BCA Assessment Report

Proposed Multi-Level Warehouse Development
61 Milperra Road, Revesby

Revision 1.1
03 April 2024
Reference: 230399

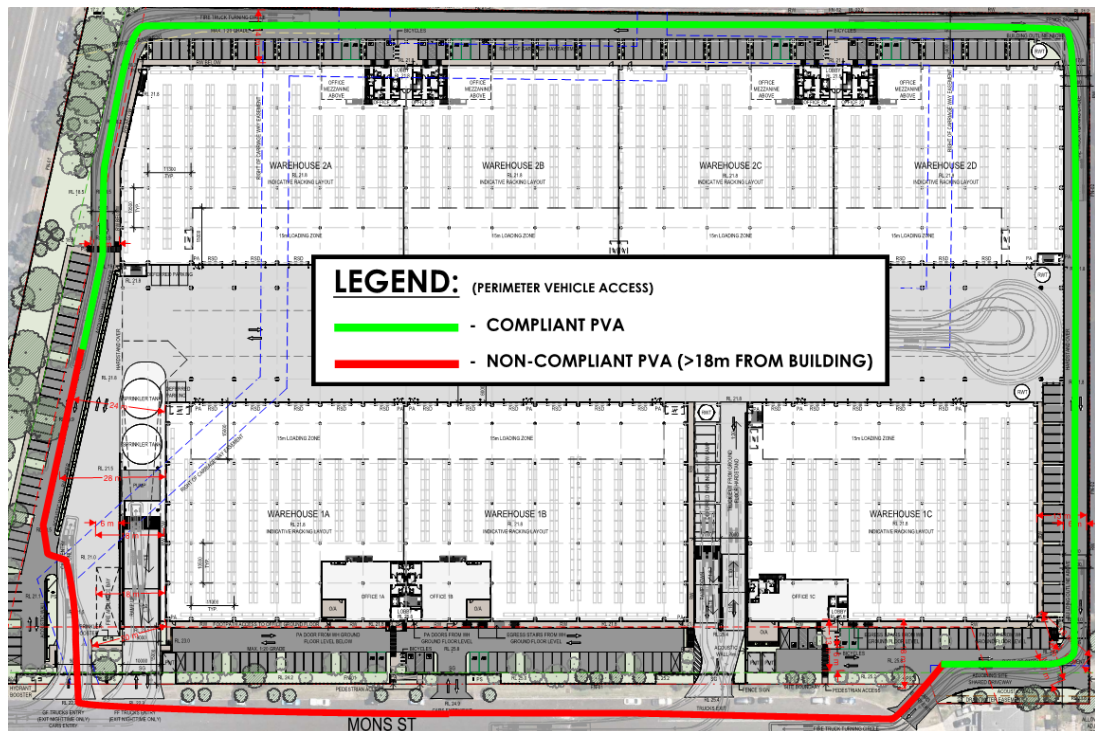
Comment: The perimeter vehicular access around the proposed development deviates from the above requirements as follows:

- + Greater than 18m from the external walls in the eastern and southern areas.

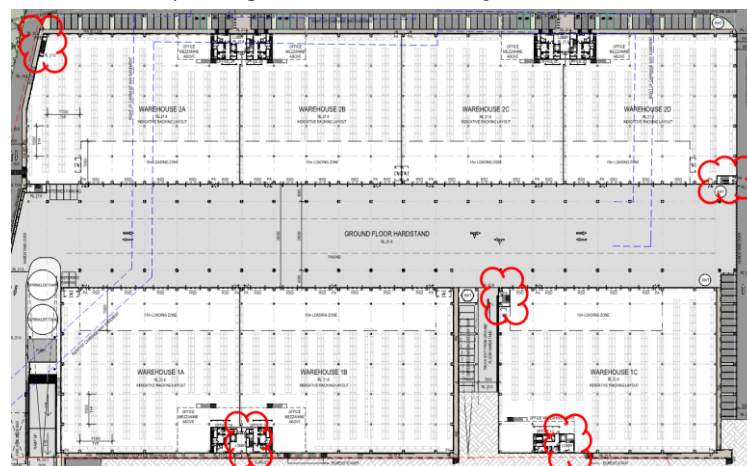
Comment: Discharge from the fire stairs serving Warehouses 1A & 1B is into a covered area, that is less than 1/3 open, and the path of travel to open space is >6m (up to 20m). It is understood this is to be addressed via a **Fire Engineered Performance Solution**. Refer to the below excerpt identifying the egress paths in **red**, and the line of the building over in **yellow**.

The point of discharge for the fire stairs adjacent Warehouse 1C & 2D is not sufficiently open, i.e. <1/3 (refer to the below excerpt, identifying the enclosed perimeter in **red**). Revised plans demonstrating compliance are to be provided with the CC application. Alternatively, it is understood this issue may be addressed via a **Fire Engineered Performance Solution**.

Rationalisation of fire rating to external walls on at the point of discharge of fire isolated stairs identified below is understood to be proposed via a **Fire Engineered Performance Solution**, as the egress paths necessitate passing within 6m of the façade.

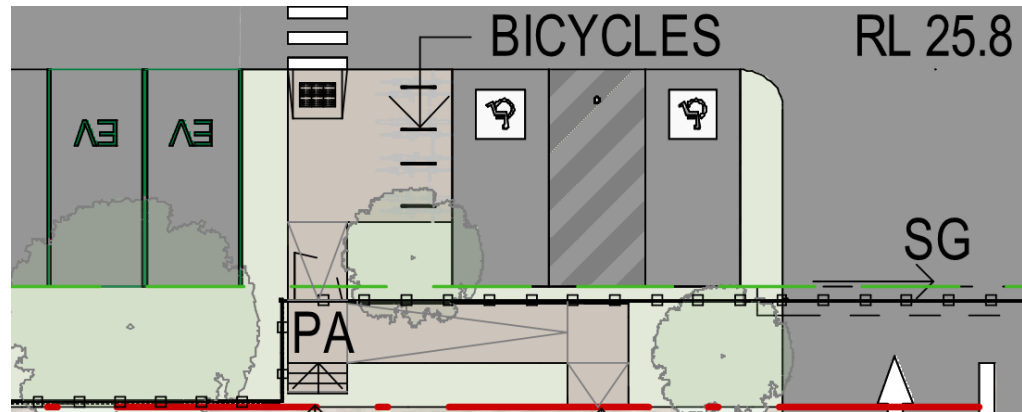
- + Details are to be provided to illustrate the gradient of this ramp and the details relating to handrails and tactiles (if required).
